Browns Ferry Nuclear Plant, Unit 2
Renewed Facility Operating License No. DPR-52
NRC Docket No. 50-260

Subject: **Response to Request for Additional Information Regarding Relief Request 2-ISI-29 (TAC NO. ME8854)**

Response to Request for Additional Information Regarding Relief Request 2-ISI-29

GR-2-09

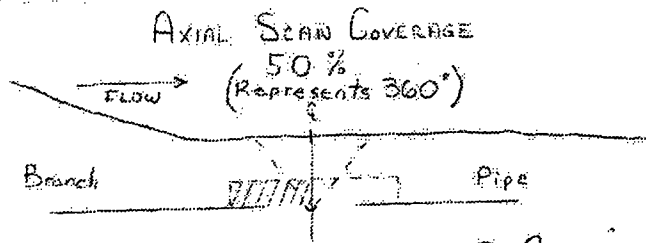
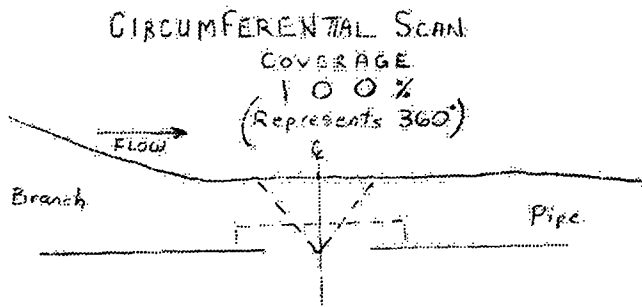
The provided coverage map does not clearly show where coverage is being claimed for the inspection and where coverage was missed. Please provide a coverage map showing the regions that were not inspected.

Attachments 1 and 2 contain copies of revised versions of Unit 2, Cycle 16 Inservice Inspection Report, UT-11-023 for GR-2-09 and Unit 2, Cycle 16 Inservice Inspection Report, UT-11-043 for RCRD-2-50, which contain detailed coverage maps indicating regions that were not inspected.

= LIMITED
SCAN
COVERAGE.
